# Delta Conveyance Project: Summary of the Preliminary Assessment of a Western Corridor

March 30, 2020

# Ship Channel Diversion

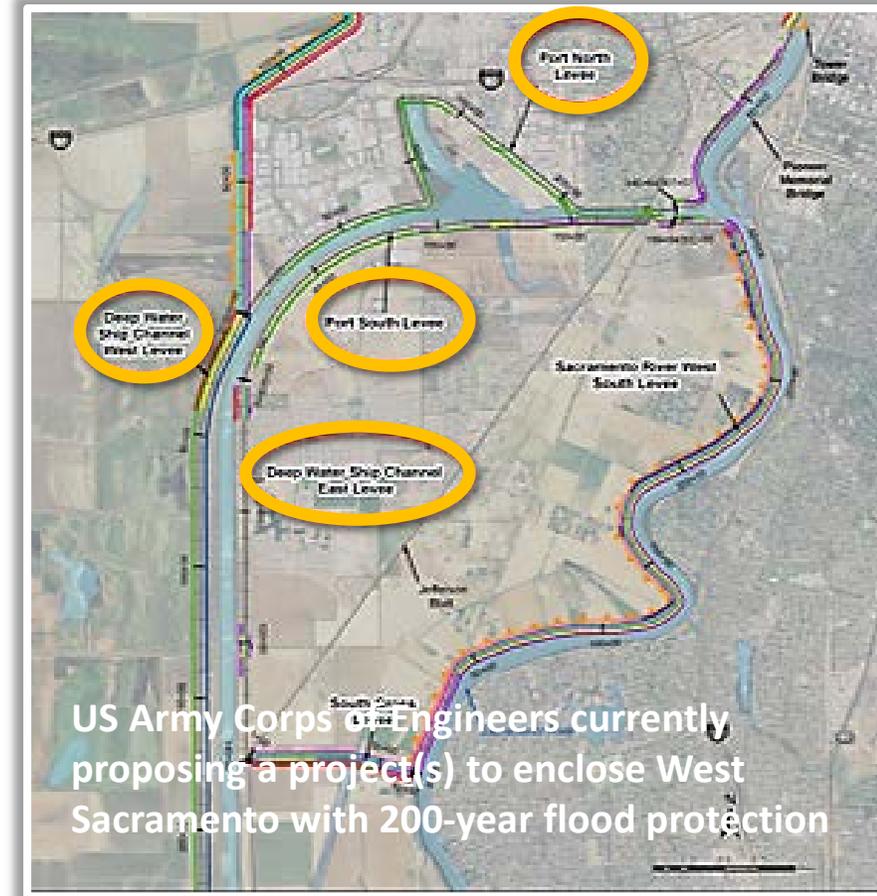
- » Use existing ship channel to divert water to southern end of and construct shipping lock on end to allow cargo transport.

- » Levees along DWSC would need to be raised from proposed shipping Lock to proposed USACE project levees to meet Delta Conveyance design criteria of 200 year flood level + Sea Level Rise.
- » Levee modifications on west side of ship channel would require regulatory permission to transport construction equipment and perform construction activities in the Yolo Bypass Wildlife Area
- » USACE has determined sediment in DWSC is contaminated - would require dredging or capping to protect water supply
- » USACE proposes mitigations along the Federal project system but does not address seismic design requirements for Delta Conveyance or non-Federal levee south of West Sacramento.

Major additional upgrades would be required.

# Ship Lock and Delta Smelt Habitat

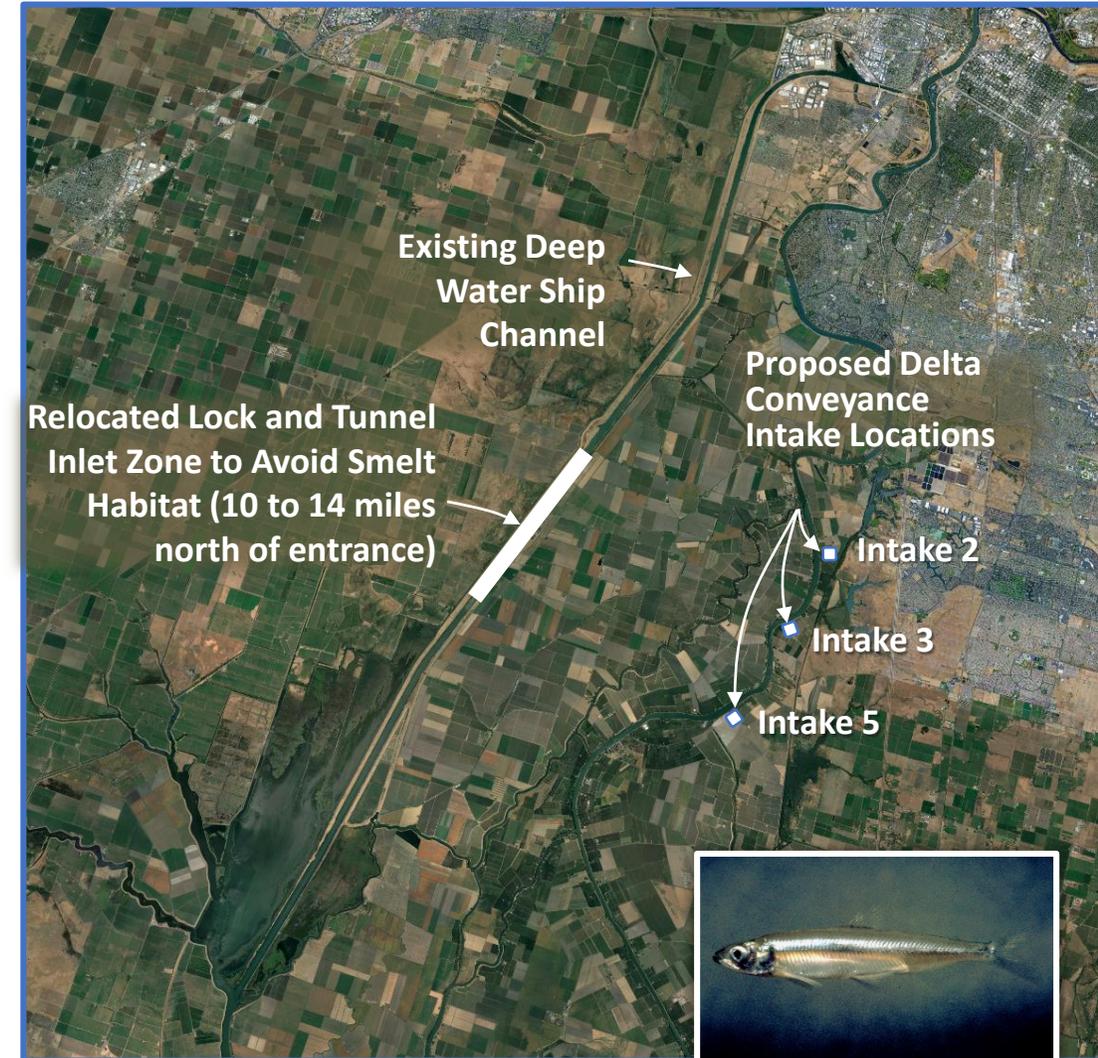
- » Construct shipping lock at southern end of Ship Channel to maximize reuse of existing Channel conveyance and allow continued cargo transport to West Sacramento.

- » The lower reach of the DWSC is core spawning and rearing habitat for Delta Smelt and unique habitat within the Cache Slough Complex which supports some of the highest occurrence of native fish species in the Delta. A new lock at the southern end of the channel would block access to this unique feature for spawning and rearing Delta Smelt. It is doubtful that regulatory permits could be secured for a lock or tunnel inlet in this location.
- » The lock and tunnel inlet shaft would need to be relocated about 10 to 14 miles further north along the ship Channel to avoid habitat disturbance.
- » The new tunnel inlet shaft location is nearly lateral to the location of the proposed intakes in the Delta Conveyance NOP. This negates any substantive reduction in total tunnel length between these two proposals.

# Dual Pipelines

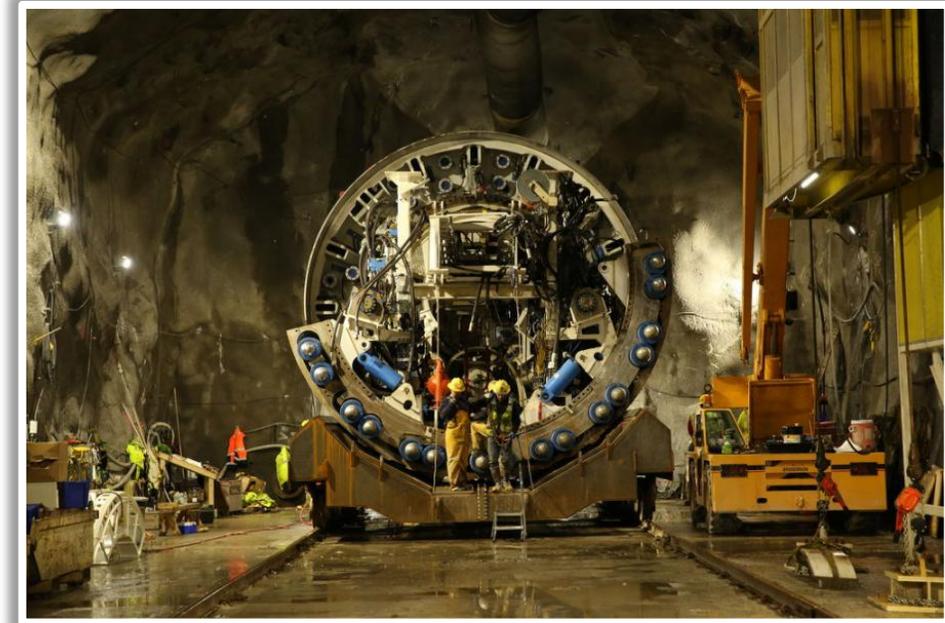
- » Construct two parallel 10-ft diameter pipelines from south end of ship channel to a new channel along the east side of the Old River channel leading to the Tracy Pumps

- » Two 10 ft diameter pipes would be woefully inadequate to transport 3,000 cfs; a single 26-ft diameter tunnel would be more cost effective.
- » Height of proposed channel levees to meet Delta Conveyance Design criteria of 200 yr flood protection and Sea Level rise would be in the range of approximately 28 ft in the South Delta Area – well above any existing levees in the area.
- » Tunneling, although more expensive than channel construction, is far more resilient and obviously has far less impact than constructing a several miles long channel to the Tracy Pumps.
- » Channel construction along Old River would require significant import of borrow material and is along areas of poor ground conditions requiring significant ground improvement.

# Construction Logistics

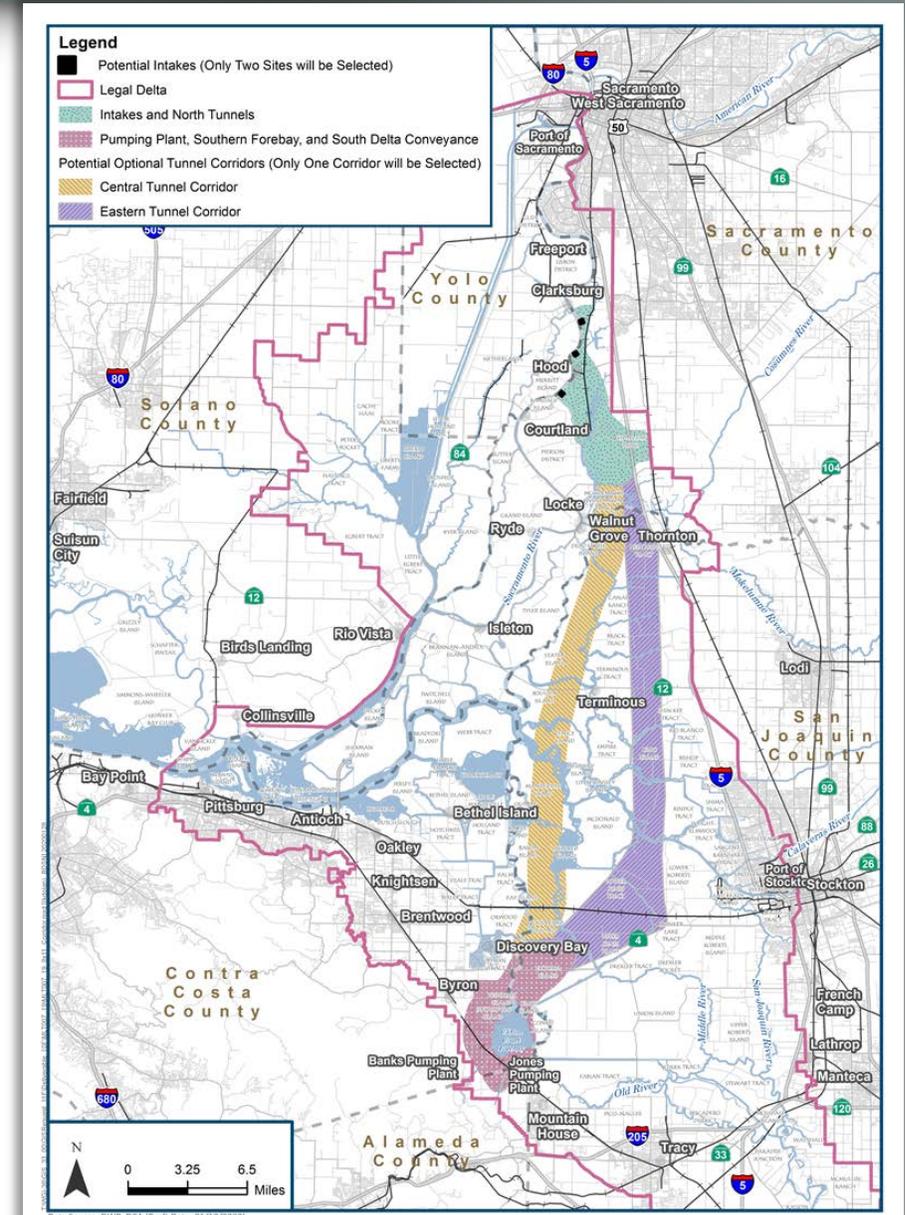
- » New bridge required in West Sacramento with new road extending south to reach east side channel levees
- » Access required in Yolo Bypass to raise west side channel levees
- » Poor access to east side of ship channel. Heavy construction traffic forced on Hwy 84 to access area. This Hwy cannot handle the capacity and loads.
- » Poor access to most islands along the alignment for heavy construction. Major logistics improvements would be required.

# Recent Addition to Garamendi Plan (2.7.20 Letter)

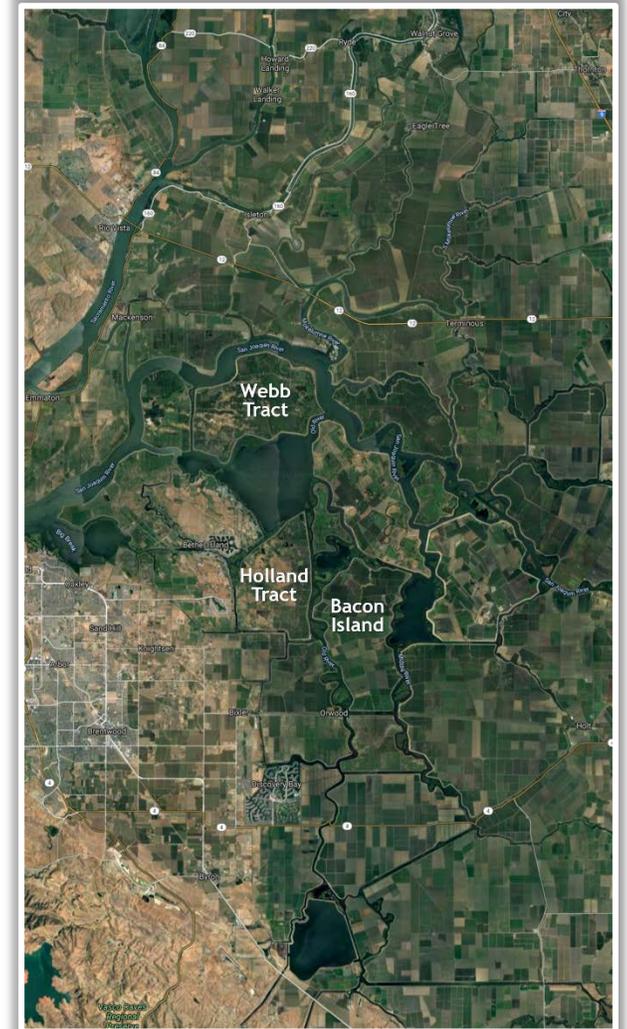
- » Divert flows in a pressurized pipeline from south lock on the Ship Channel to three new reservoirs on Bacon Island, Holland Tract, and Webb Tract.

- » The islands in the inner Delta have a deep layer of peat soil at the surface that would severely contaminate the water supply with organic material. This organic material creates a wide range of carcinogenic compounds when treated with disinfectants. This is a completely unacceptable proposition from a public health perspective.

- » The levees on these islands would require significant upgrades to meet the design earthquake loads, 200-year flood levels and sea level rise.
- » This alternate proposal would add another 3,000 cfs pump station and flow control structures (1 per island) to divert flows to the existing SPW facilities. Each pump station requires approximately 50 acres of land (mostly zoned agricultural in these areas).

- » The amount of storage available on these islands may meet daily operational needs and eliminate the need for the Southern Forebay but is insufficient in size to provide any meaningful type of seasonal storage.
